Village of Arlington Heights
Plat and Subdivision Committee
Community Room, 3rd Floor
Arlington Heights Village Hall
33 S. Arlington Heights Road
Arlington Heights, IL 60005
January 13, 2016
6:30 PM

Item: Westgate Dental - 2932 W. Euclid Ave. - T1516

STAFF DEVELOPMENT COMMITTEE REPORT

To: Plat and Subdivision Committee
Prepared By: Bill Enright, Deputy Director Planning and Community Development
Meeting Date: January 13, 2016
Date Prepared: January 7, 2016
Project Title: Westgate Dental
Address: 2932 W. Euclid Ave

PRELIMINARY PLAT
516 LINCOLN SUBDIVISION
ARLINGTON HEIGHTS, IL

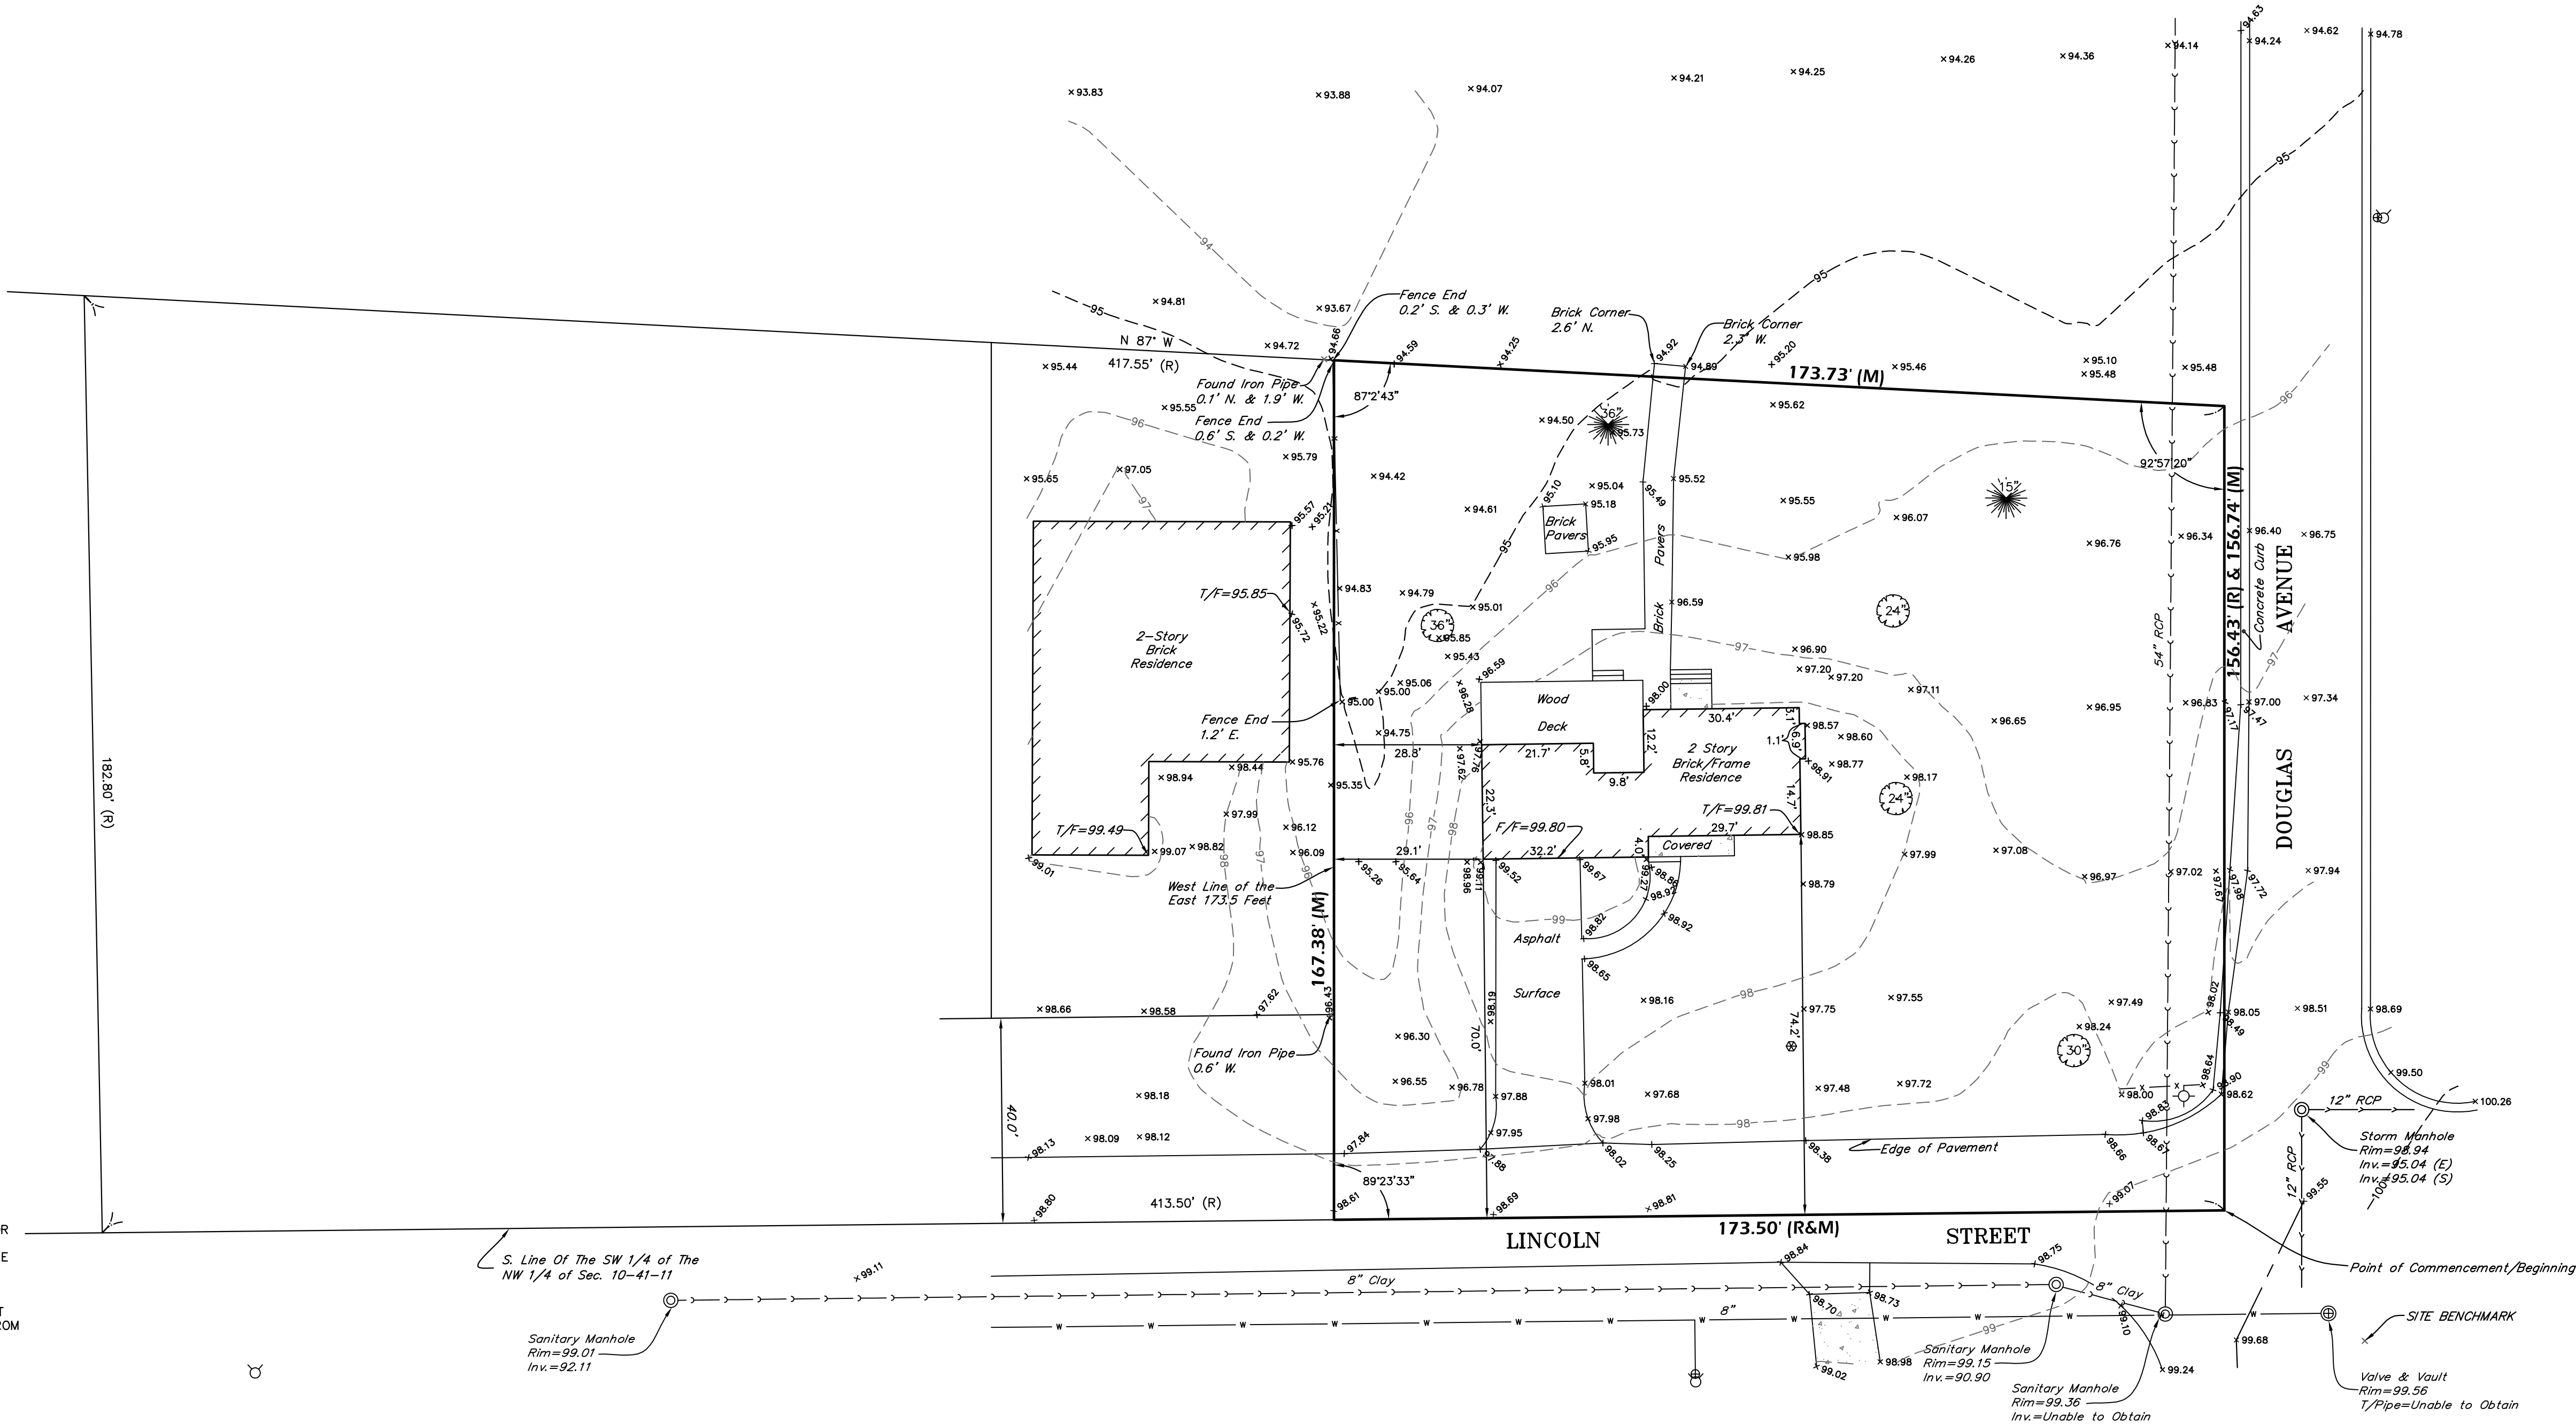
Currently the south property line extends to the middle of Lincoln Street, therefore the proposed Plat of Subdivision provides for a dedication of the south 40 feet along Lincoln Street for additional right of way. The lot area proposed on the Plat accounts for that dedication of land.

There is an existing 54 inch MWRD interceptor sewer set back 11 feet and running along the east property line. It is not known whether or not there is an existing easement for this sewer. Therefore a Plat of Survey will be required in order to determine whether there is an existing easement, and to determine any known encumbrances, conditions and easements, etc. IT may be necessary to grant an easement for this sewer. Also, a fee in lieu of detention shall be required as part of Final Plat approval.

There are no sidewalks currently adjacent to the property. Sidewalks are intermittent in the area so either sidewalks will be required with the development or an estoppel required for future installation of sidewalks. Also, if the house on lot 1 seeks a driveway off of Douglas Avenue, then a permit from Mt. Prospect will be required as the Douglas right of way is within the Mt. Prospect municipal limits.

1. Submittal of a Preliminary Plat of Subdivision.
2. Submittal of a Plat of Survey for clarification as to whether there is an existing easement for the MWRD sewer.
3. Dedication of 40 feet long the south property line for Lincoln Street right of way.
4. Provision of an easement along the east lot line in order to accommodate the MWRD sewer if the easement does not currently exist.
5. A fee in lieu of detention shall be required.
6. Land dedication fees are required for the new additional lot as part of a building permit for the new home on lot 1.
